UNITED STATES
NUCLEAR REGULATORY COMMISSION
WASHINGTON, D.C. 20555-0001

February 16, 2017

SUBJECT: DRESDEN NUCLEAR POWER STATION, UNITS 2 AND 3 – SAFETY
EVALUATION REGARDING IMPLEMENTATION OF MITIGATING
STRATEGIES AND RELIABLE SPENT FUEL POOL INSTRUMENTATION
RELATED TO ORDERS EA-12-049 AND EA-12-051 (CAC NOS. MF1046,
MF1047, MF1050, AND MF1051)

Figure 1 - "Dresden SFP Levels of Monitoring"

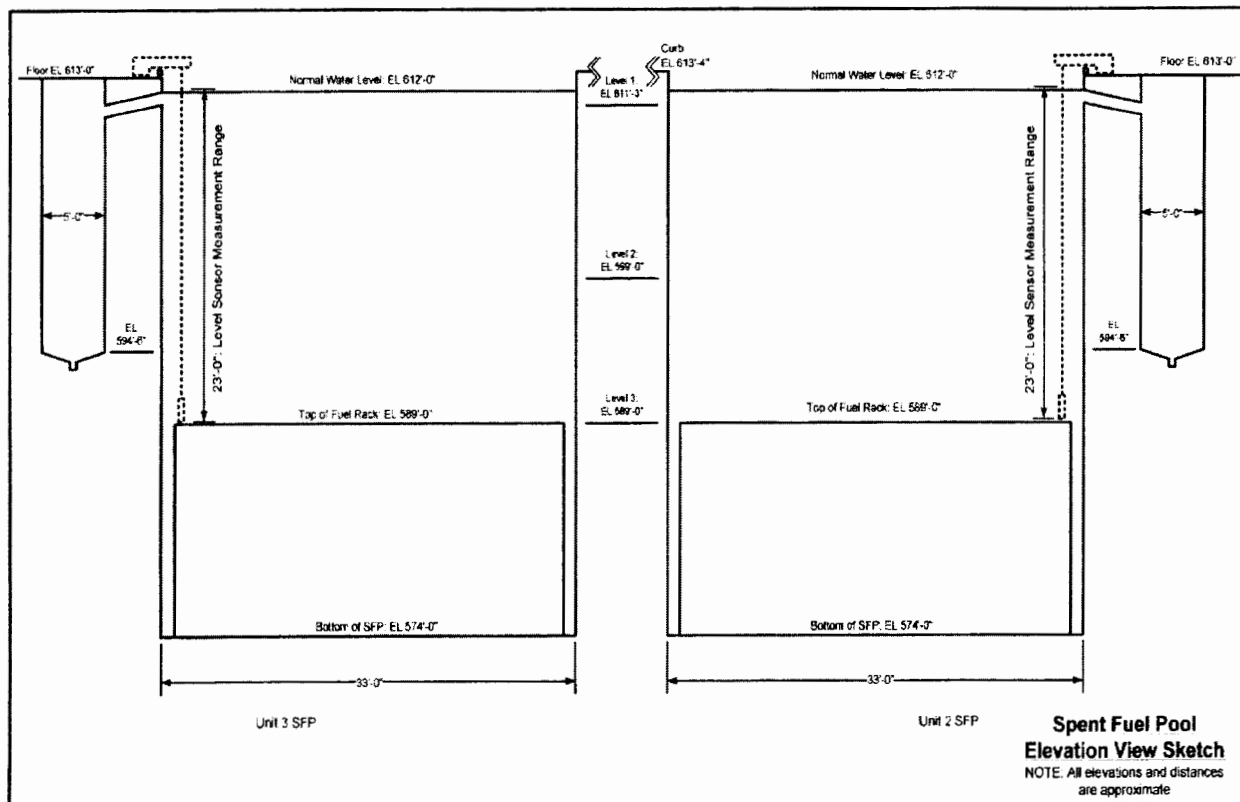
In its letter dated July 18, 2013 [Reference 26], the licensee provided a sketch depicting the final SFP levels of monitoring and the instrument's measurement range (Figure 1 of this evaluation). In this figure, the measurement range is from 612' 0" to 589' 0" plant elevation. The NRC staff noted that the measurement range will cover Levels 1, 2, and 3, as described in Section 4.1 above.
